## Product/Process Change Notice (PCN)

PCN #: WE\_LAN\_10G\_20171013

Product Affected: WE-LAN 10G

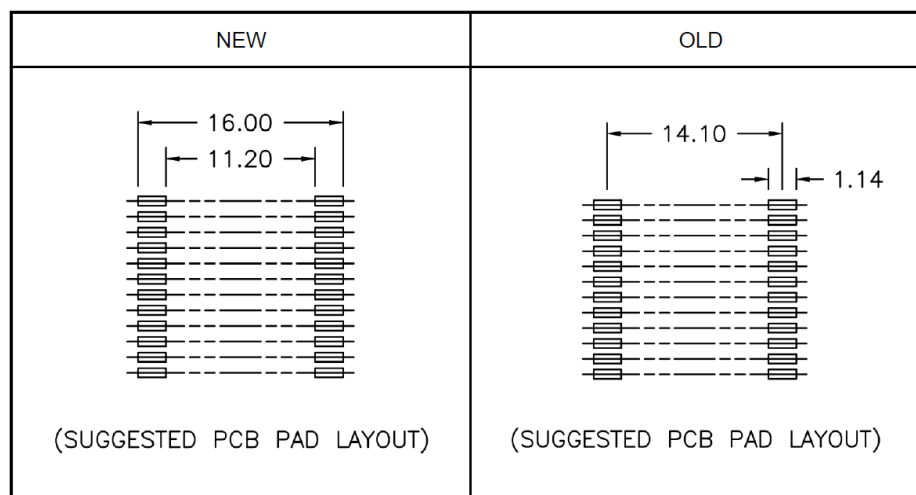
Due to a database mismatch, the suggested pad length in the PCB layout for mentioned P/Ns has been updated. The old land pattern can still be used. Nevertheless, Würth Elektronik eiSos suggests the new PCB layout for new designs. With the new PCB layout, the soldering reliability of the parts will be increased.

Part numbers updated:

749050010U, 749050017, 749050018, 749052012, 749053010, 749053011, 749053012 and 749053013
